Hydrogeologic  
Workplan  
R-14  
TA: 35

**Subject:** R-14

# R-14 Planned Design Rev. A (7/3/02)

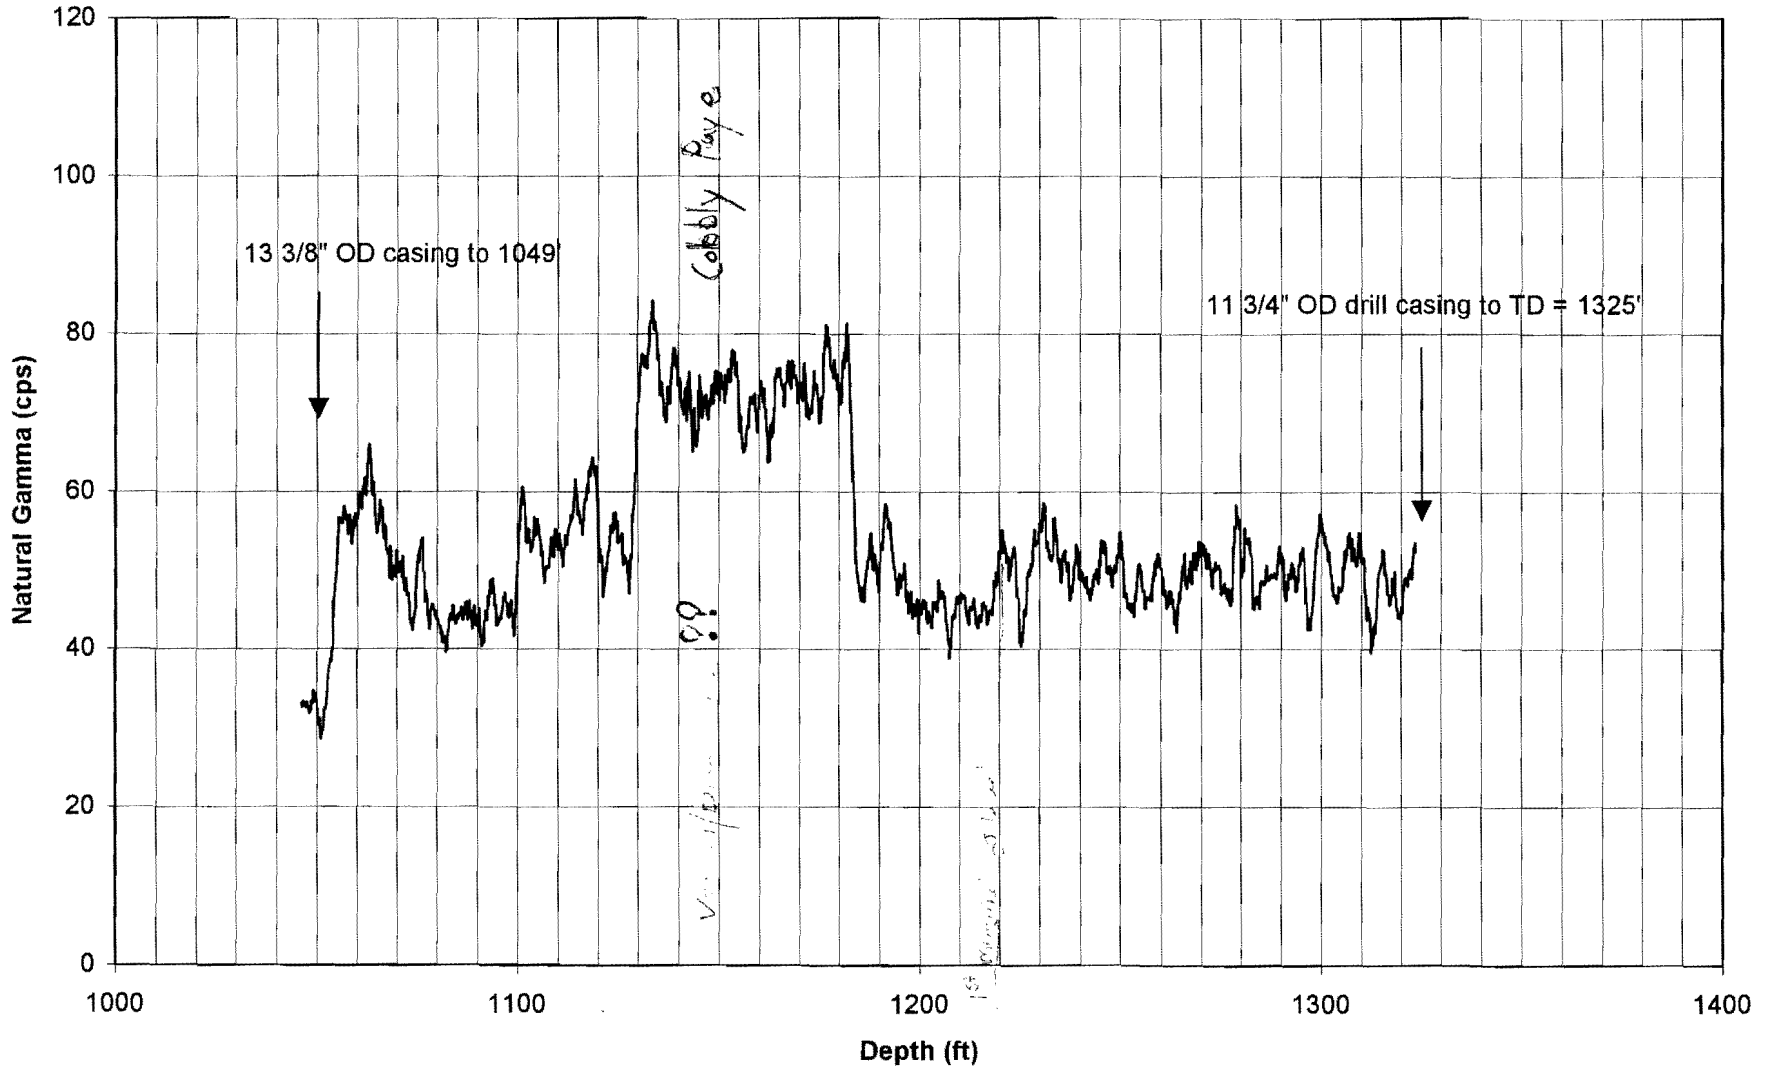
- 1) Although NMED agreed to the 2 port Westbay system with the first screen located 10 feet below the top of saturation; our preference for R-14 was a single completion, screened across the top of the regional aquifer.
- 2) LANL should pressure seal the annular space in areas of saturation rather than floating the bentonite pellets in these areas to minimize the chance of bridging.
